Access Compliance Report

(Curb Ramps)

Intersection ID: 27538	Main Street: ALTON_FARM_LN	Cross Street: CHARLOTTE_VIEW_DR	Location: NE
ADA ID: 87BBB63788C6	Ramp Type: PerpDiag	Initial Pass/Fail: Fail	Overall Compliance: No
Severity Score: 35			
Codes/Mitigation Info/Possible Solution		Field Measurements/Component Compliance

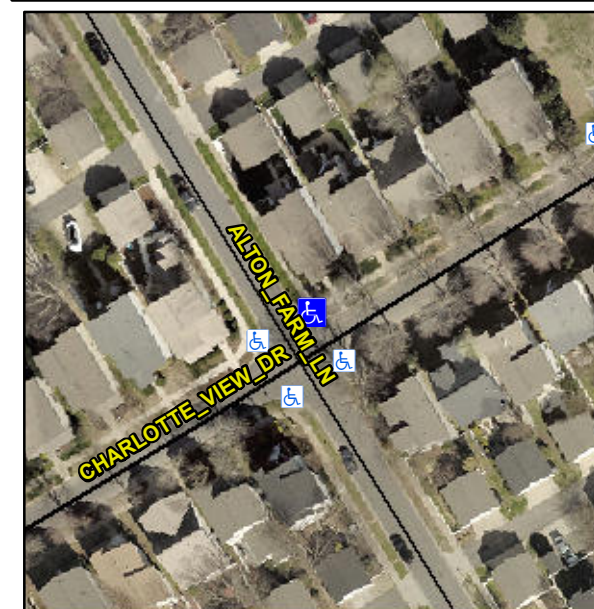
Not Found, R304.5.1

Compliance	Description	Data	Compliance	Description	Data
N/A	Ramp Length (in)	51.0	Yes	Ramp Slope (%)	5.6
No	Ramp Width (in)	31.0	Yes	Ramp XSlope (%)	1.8
N/A	Flare Type LT	N/A	N/A	Flare Type RT	N/A
N/A	Flare Slope LT (%)	N/A	N/A	Flare Slope RT (%)	N/A
N/A	Flare Traversable LT?	N/A	N/A	Flare Traversable RT?	N/A
N/A	Landing Length (in)	N/A	N/A	DWS Provided?	N/A
N/A	Landing Width (in)	N/A	N/A	DWS Contrast?	N/A
N/A	Landing Slope (%)	N/A	N/A	DWS Length (in)	N/A
N/A	Landing X Slope (%)	N/A	N/A	DWS Full Width?	N/A
N/A	Landing Curb? (Y/N)	N/A	N/A	DWS Offset (in)	N/A
N/A	Shared Landing?	N/A			
N/A	Gutter Ponding?	N/A	N/A	Gutter Slope (%)	N/A
N/A	Gutter Lip Ht (in)	N/A	N/A	Gutter X Slope (%)	N/A
N/A	Painted X Walk1?	No	N/A	Painted X Walk2?	No
	X Walk 1 Direction	To SW		X Walk 2 Direction	To SE
N/A	X Walk 1 Width (in)	N/A	N/A	X Walk 2 Width (in)	N/A
	X Walk 1 Slope (%)	0.4		X Walk 2 Slope (%)	0.1
	X Walk 1 X Slope (%)	1.5		X Walk 2 X Slope (%)	0.2

Remove & Replace Curb Ramp With Two New Directional Ramps or Equivalent.
